Address: 133 Babcock Street

<u>Description of Work</u>: This property appeared before the commission in January 2021, where the applicant requested approval to rebuild the front porch that had been demolished without permits. The approved plans included drawings showing the proposed design of the porch, that largely matched the previous design (Attached). Zoning Enforcement officer Jim Tanner Issued a citation for failure to follow the conditions of the HPC approval. Some features in the approved drawings are not present on the current porch (running trim and brackets have been removed).

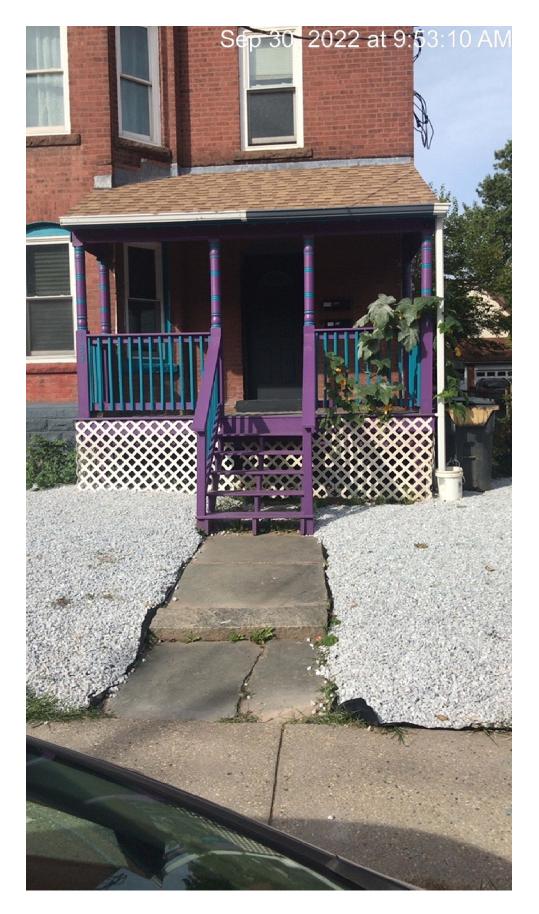
<-Missing running trim and brackets <-Column posts are of a different design to the original <-Step posts are of a different design to the proposed <-3 inch wood trim missing around what appears to be vinyl lattice

<-Removed or
obscured
Feature</pre>
